CITY OF MANDAN, NORTH DAKOTA MAIN STREET WATER IMPROVEMENTS DISTRICT #39, WATER IMPROVEMENT PROJECT 96-2, PHASE III

Record Drawing

DATE: 2-14-97

REV.	DATE	DESCRIPTION	BY
2/14/97		RECORD DRAWING	DMS
CITY OF MANDAN			
DISTRICT #39, WATER IMPROVEMENT PROJECT 98-2, PHASE III			
STA 170+00 TO STA 174+00			
ULTEIG ENGINEERS, INC.			
DRAWN BY: MJH	SCALE: 1" = 40'	PROJECT NO. 95834	
CHECKED BY: BPM	DATE: MAY 17, 1995	SHEET 10 OF 20

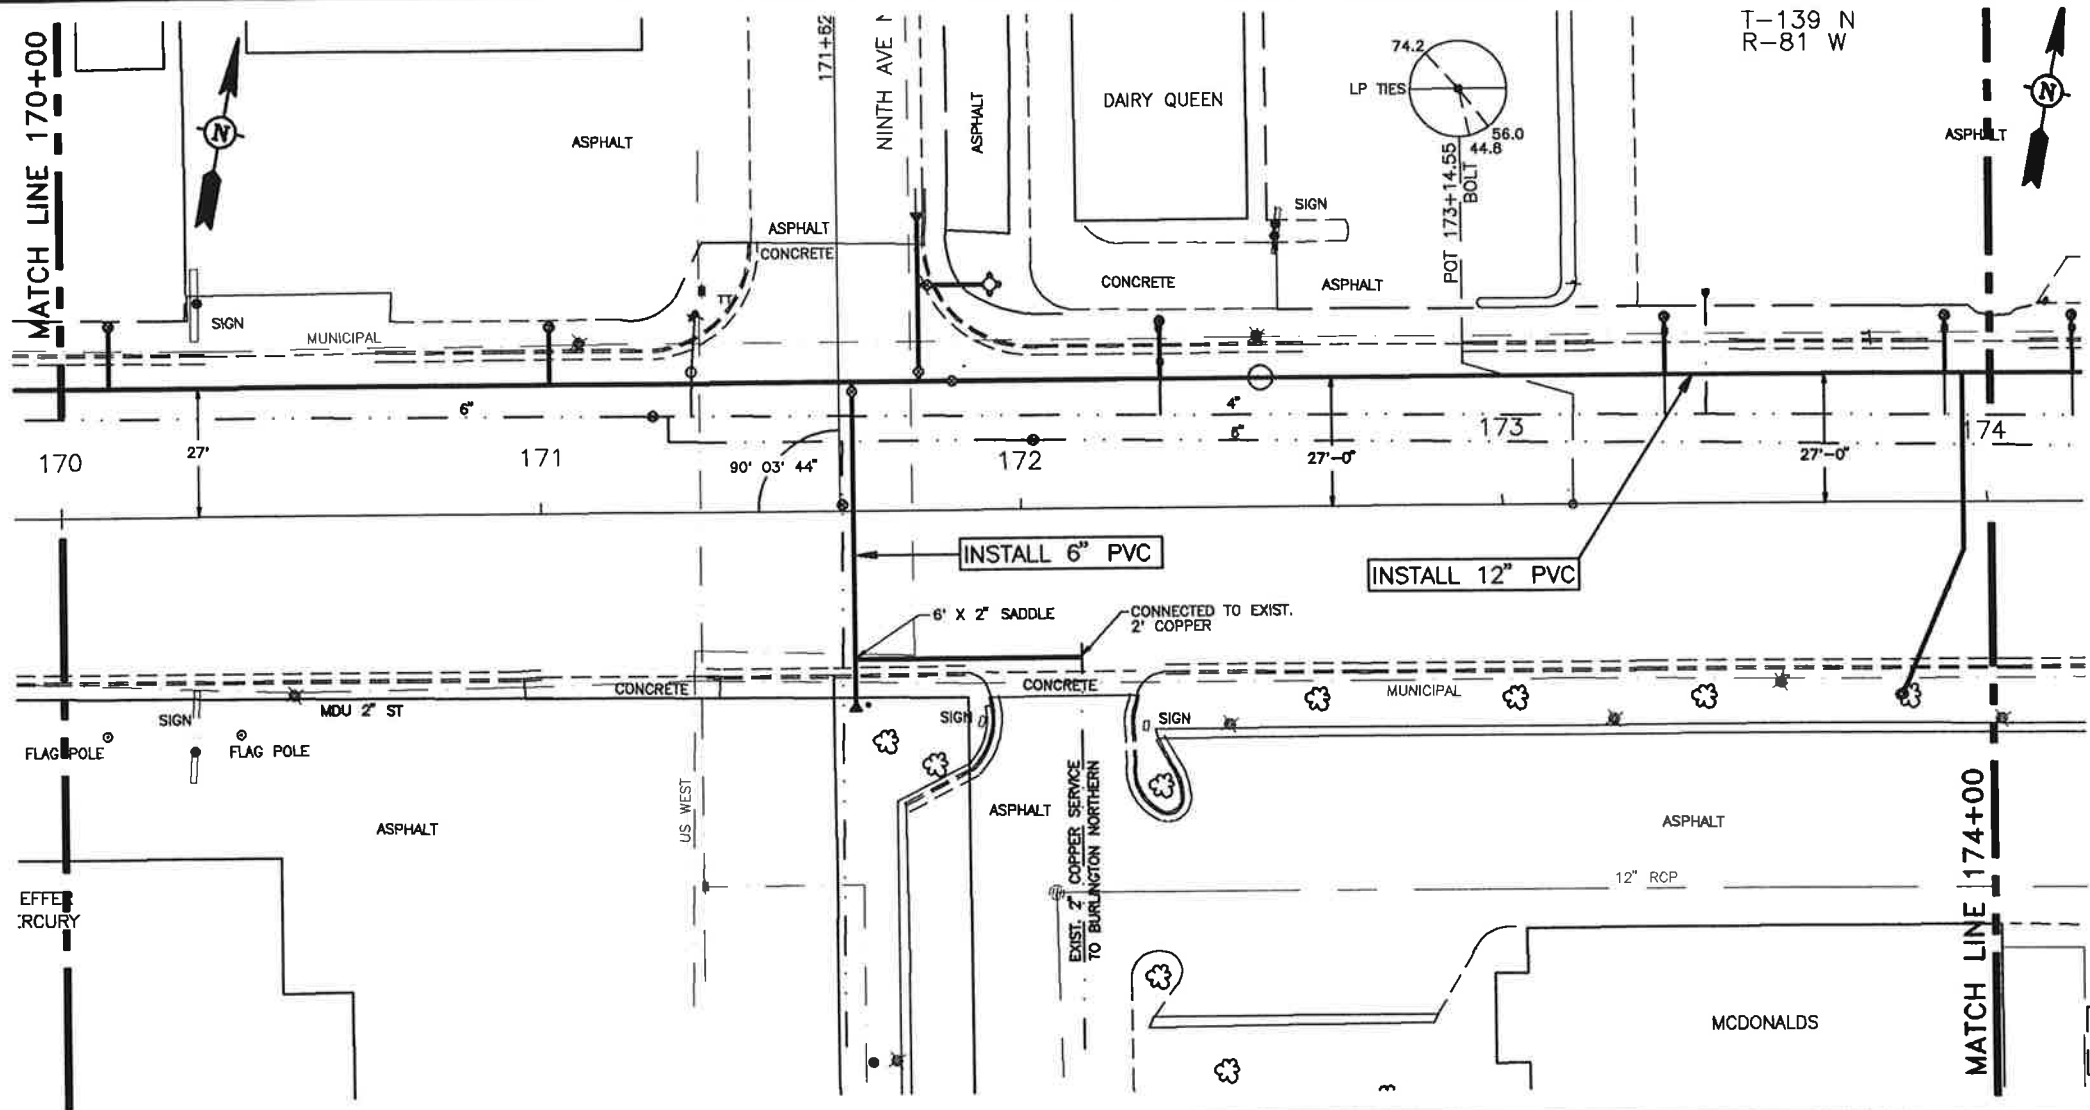
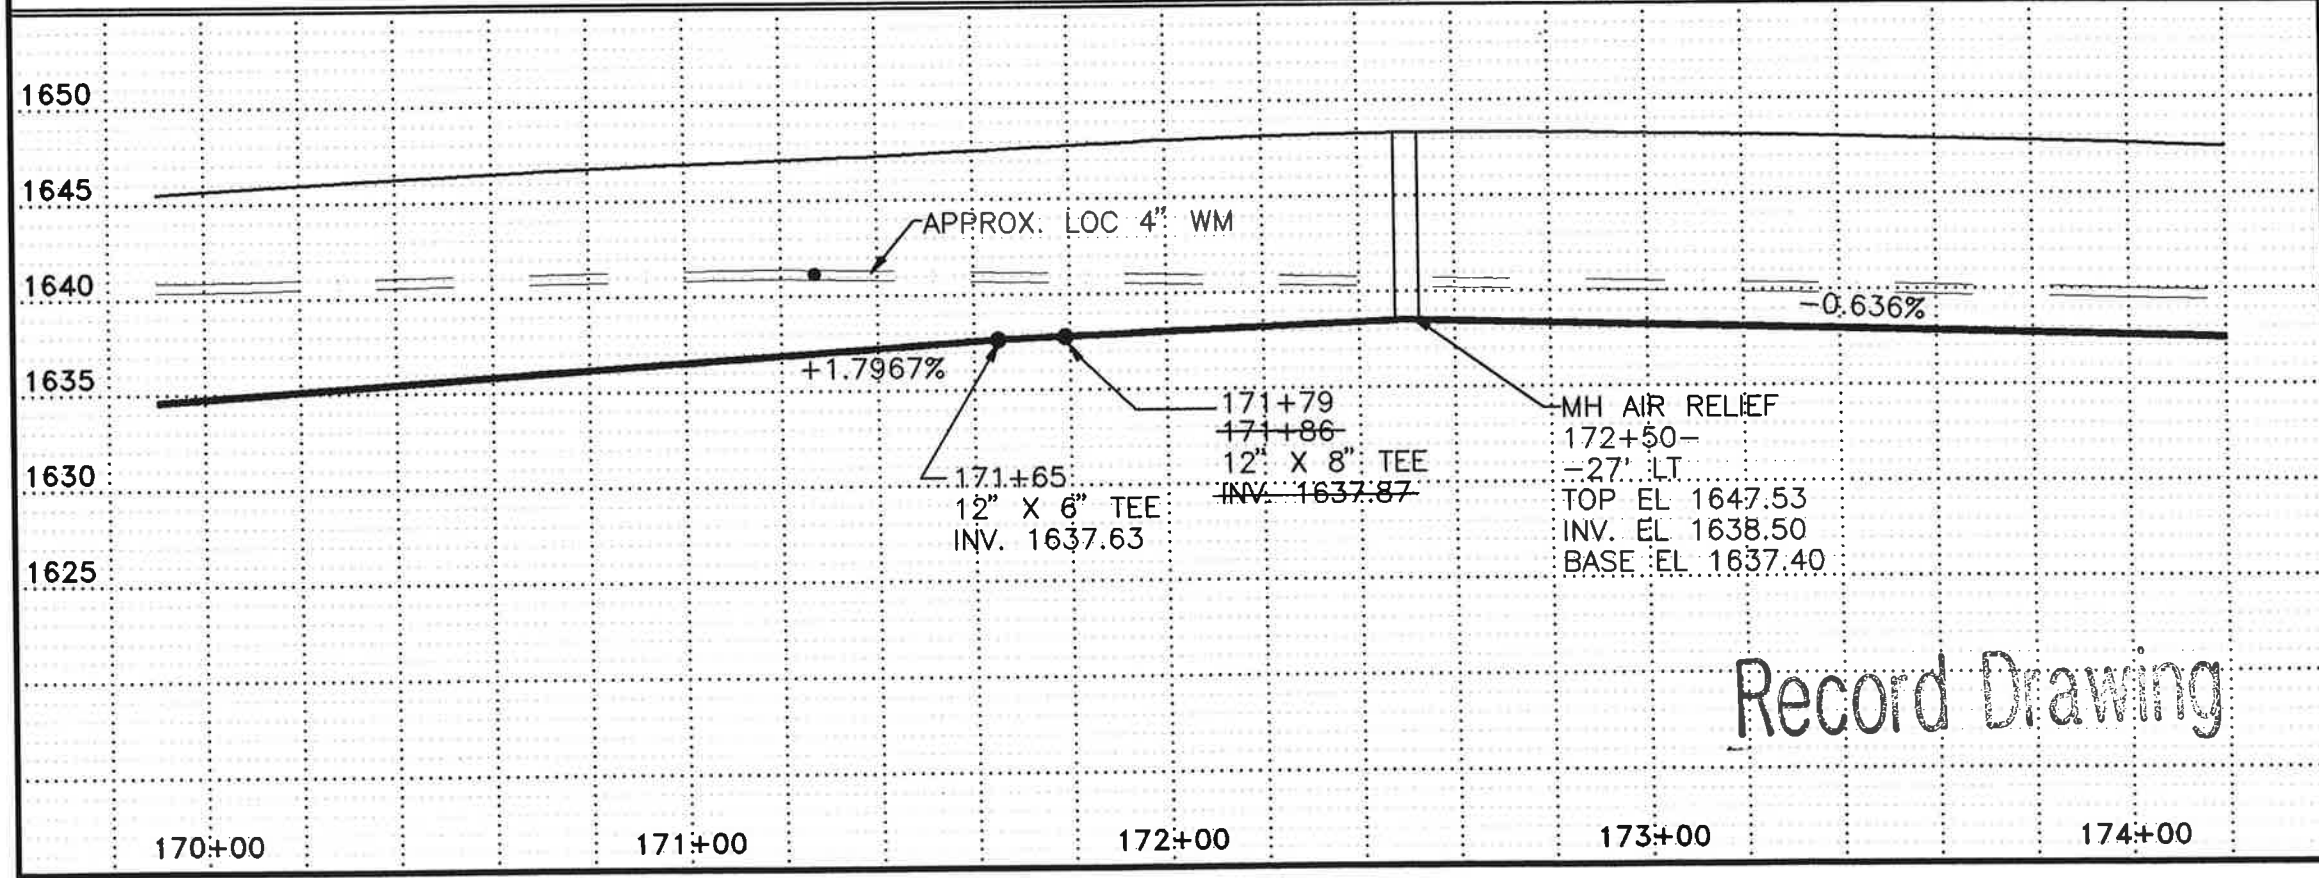
6" HYDRANT		
171+94 - 47' LT	1 EA	
GATE VALVE AND BOX, 6"		
171+65 - 25' LT	1 EA	
+81 171+89 - 47' LT	1 EA	
GATE VALVE AND BOX, 8"		
+79 171+86 - 29' LT	1 EA	
GATE VALVE AND BOX, 12"		
+86 171+83 - 27' LT	1 EA	
WATERMAIN, 6" PVC		
171+65 - 27' LT TO 171+65 - 40' RT	67 LF	
+79 171+86 - 47' LT TO 171+94 - 47' LT	15-8 LF	
WATERMAIN, 8" PVC		
+79 171+86 - 27' LT TO 171+86 - 60' LT	33 LF	
WATERMAIN, 12" PVC		
170+00 - 27' LT TO 174+00 - 27' LT	400 LF	
FITTINGS, DUCTILE IRON		
171+65 - 27' LT	12" X 6" TEE	115.423 LBS
171+65 - 40' RT	2 - 6" 1/8 BENDS	62 LBS
+79 171+86 - 27' LT	12" X 8" TEE	123.437 LBS
+79 171+86 - 47' LT	8" X 6" TEE	80.73 LBS
+79 171+86 - 60' LT	8" PLUG	26 LBS
MANHOLE, AIR RELIEF		
172+50 - 27' LT	1 EA	
WATER SERVICE LINE 1-1/2" COPPER		
170+10 - 27' LT TO 170+10 - 40' LT	13 ++ LF	
172+29 - 27' LT TO 173+29 - 39' LT	12 ++ LF	
173+34 - 27' LT TO 173+34 - 39' LT	12 ++ LF	
+85 173+50 - 27' LT TO 173+50 - 40' RT	67 LF

173+91 - 27' LT TO 173+91 - 39' LT	12 ++ LF	
171+02 - 27' LT TO 171+02 - 39' LT	12 LF	
WATER SERVICE CONNECTION 1 1/2"		
170+10 - 27' LT	1 EA	
172+29 - 27' LT	1 EA	
173+34 - 27' LT	1 EA	
+85 173+50 - 27' LT	1 EA	
173+91 - 27' LT	1 EA	
171+02 - 27' LT	1 EA	
CURB STOP AND BOX 1-1/2"		
170+10 - 40' LT	1 EA	
172+29 - 39' LT	1 EA	
173+34 - 39' LT	1 EA	
+82 173+50 - 40' RT	1 EA	
173+91 - 39' LT	1 EA	
171+02 - 39' LT	1 EA	
REMOVE HYDRANT		
171+33 - 40' LT	1 EA	
WATER SERVICE CONNECTION 2"		
171+85 - 31' RT	1 EA	
WATER SERVICE LINE 2"		
171+65 - 31' RT TO 172+12 - 31' RT	47 LF

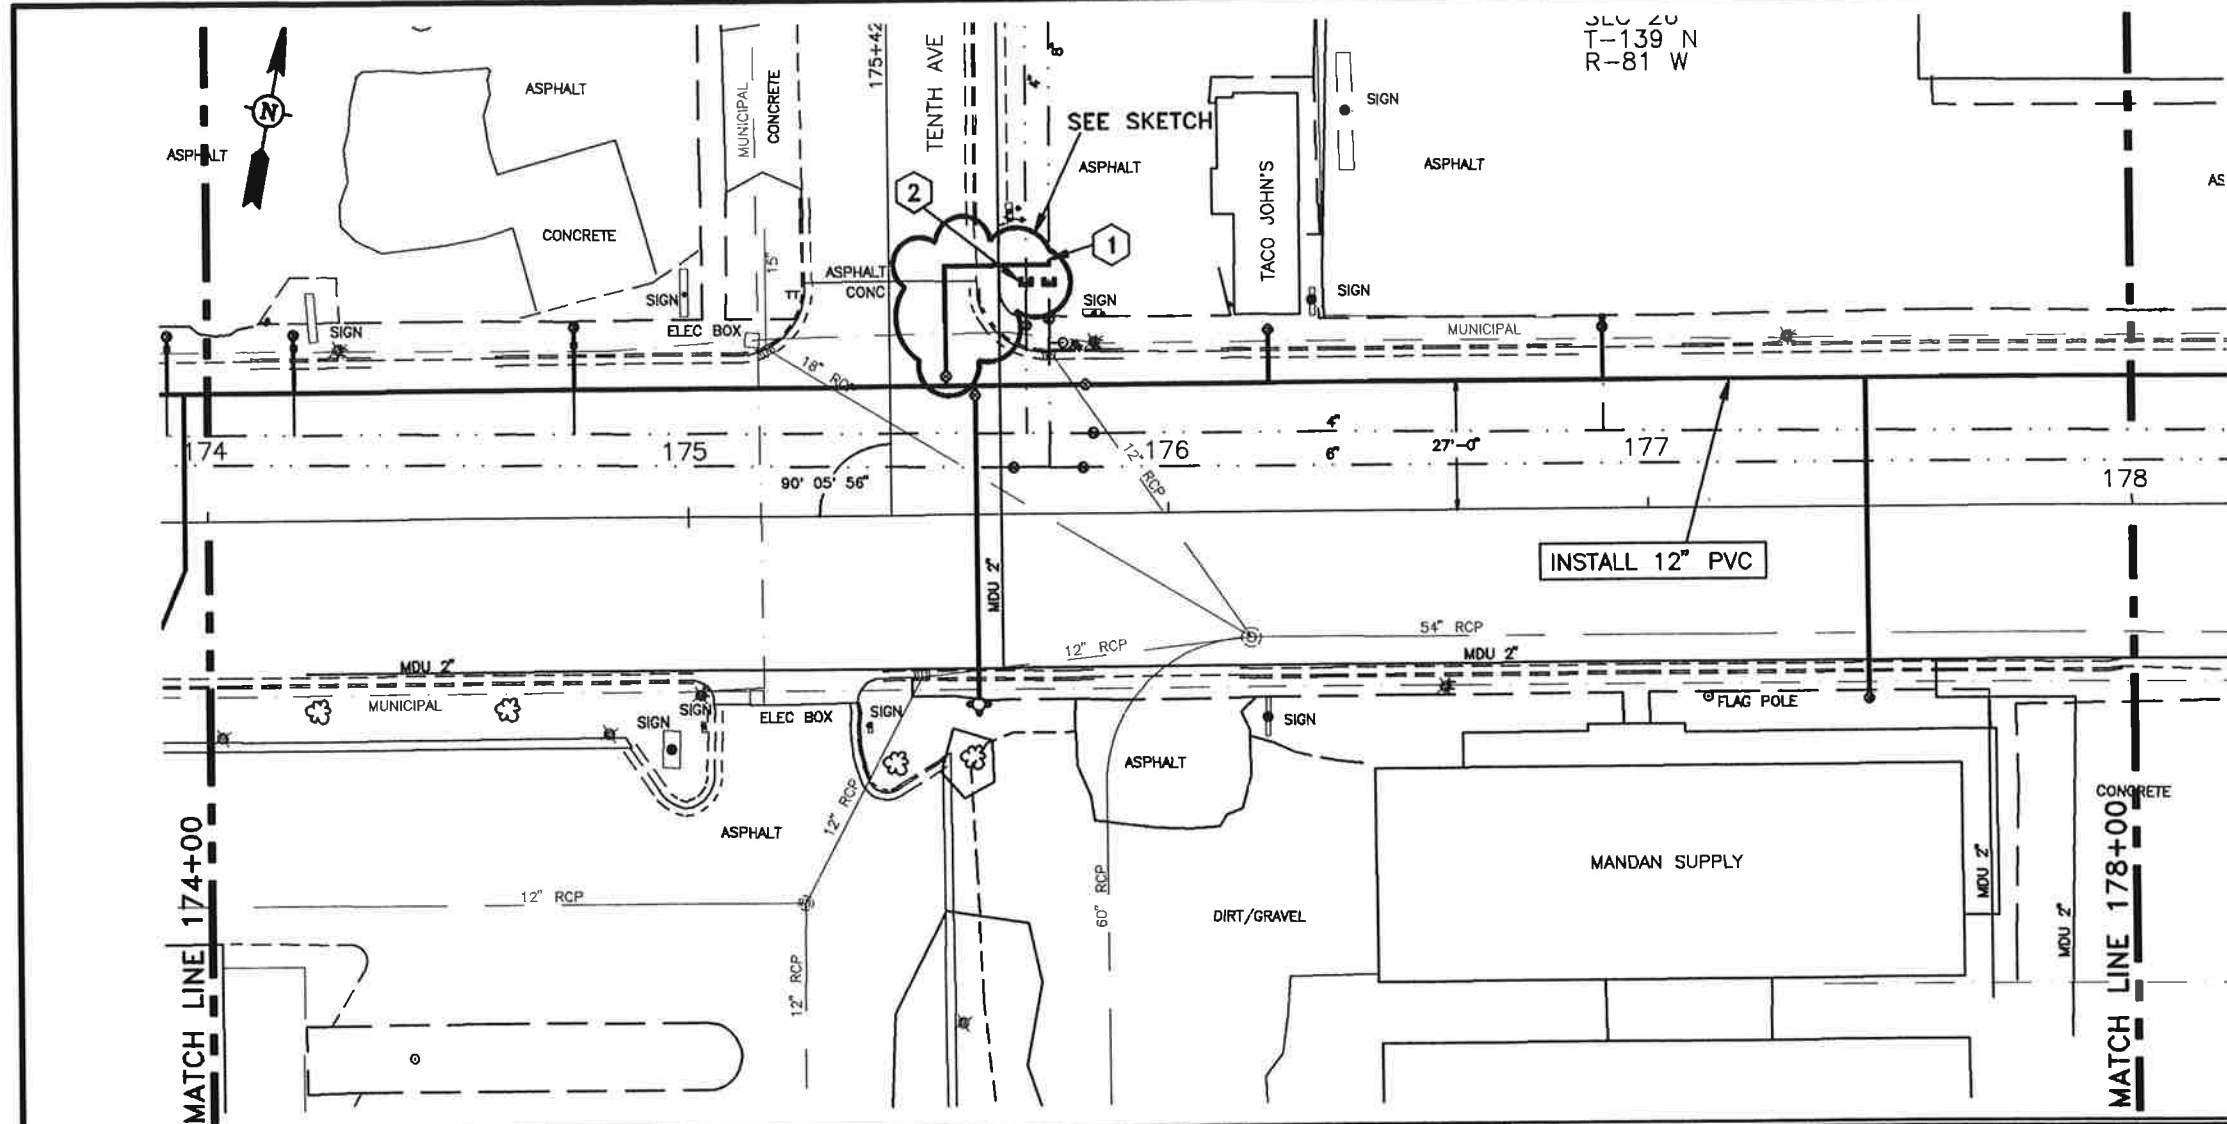
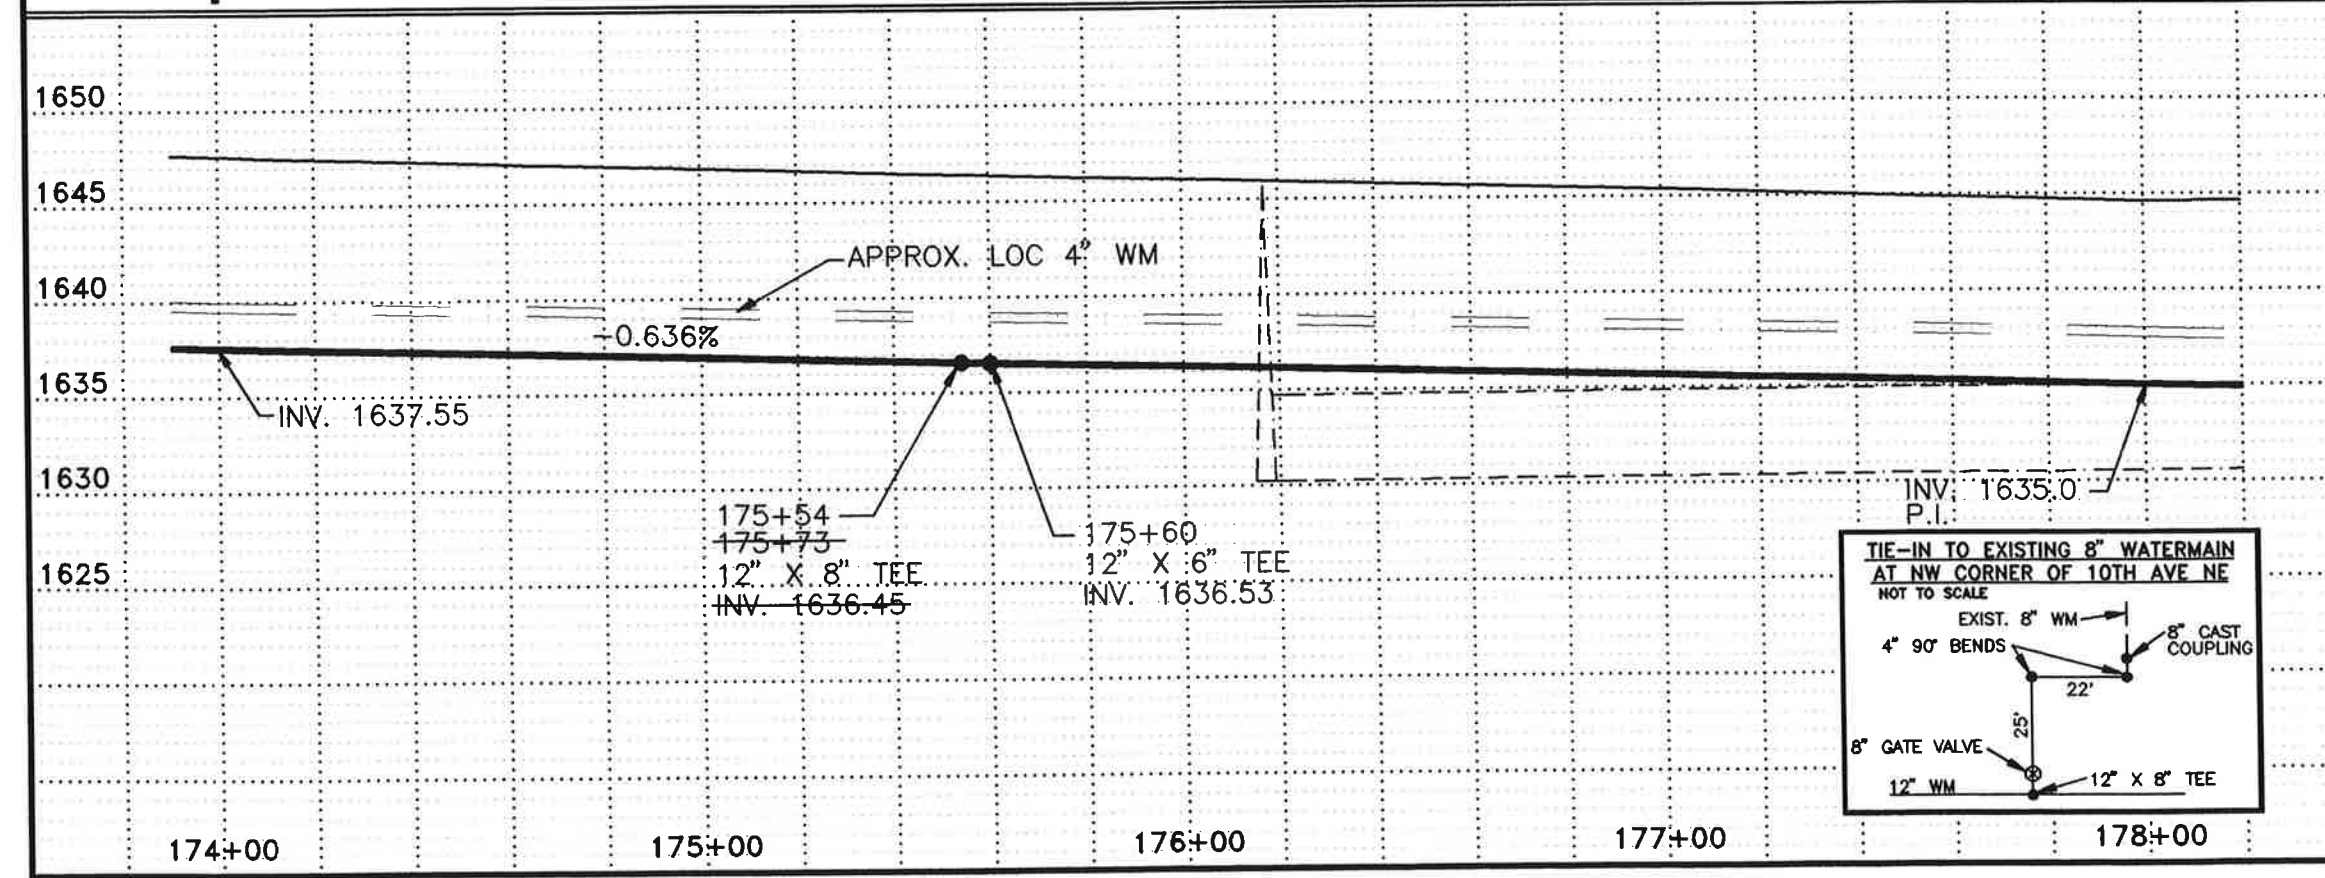
6" HYDRANT	
175+60 - 25' 39.5' RT	1 EA
GATE VALVE AND BOX, 6"	
175+60 - 24' LT	1 EA
GATE VALVE AND BOX, 8"	
+54 175+73 - 28' 30' LT	1 EA
GATE VALVE AND BOX, 12"	
+83 175+70 - 27' LT	1 EA
WATERMAIN, 6" PVC	
175+60 - 27' LT TO 175+60 - 39.5' RT	66.5 LF
WATERMAIN, 8" PVC	
+54 175+73 - 27' LT TO 175+73 - 49' 55" LT	22 28 LF
175+54 - 27' LT TO 175+54 - 52' LT	25 LF
WATERMAIN, 12" PVC	
174+00 - 27' LT TO 178+00 - 27' LT	400 LF
FITTINGS, DUCTILE IRON	
175+60 - 27' LT	12" X 6" TEE 115-423 LBS
+73 175+70 - 48' 55" LT	4" PLUG 10-8 LBS
+53 175+73 - 27' LT	12" X 8" TEE 123-437 LBS
175+73 - 55' LT	2 8" 1/8" BENDS 184 LBS
175+78 - 48' LT	5" PLUG 28 LBS
WATER SERVICE LINE 1-1/2" COPPER	
174+76 - 27' LT TO 174+76 - 40' 38" LT	13-44 LF
176+21 - 27' LT TO 176+21 - 38' LT	11 LF
176+91 - 27' LT TO 176+91 - 38' LT	11 LF
+45 177+05 - 27' LT TO 177+05 - 40' RT	67 LF
WATER SERVICE LINE 2" COPPER	
174+18 - 27' LT TO 174+18 - 38' 38" LT	12-44 LF

CURB STOP AND BOX 1-1/2"	
174+76 - 40' 38" LT	1 EA
176+21 - 38' LT	1 EA
176+91 - 38' LT	1 EA
177+05 - 40' RT	1 EA
CURB STOP AND BOX 2"	
174+18 - 38' 38" LT	1 EA
REMOVE HYDRANT	
175+80 - 36' LT	1 EA

① CONNECTED
CONNECT NEW 8" W.M. TO
EXISTING 8" W.M.

② PLUGGED
ALSO EXISTING
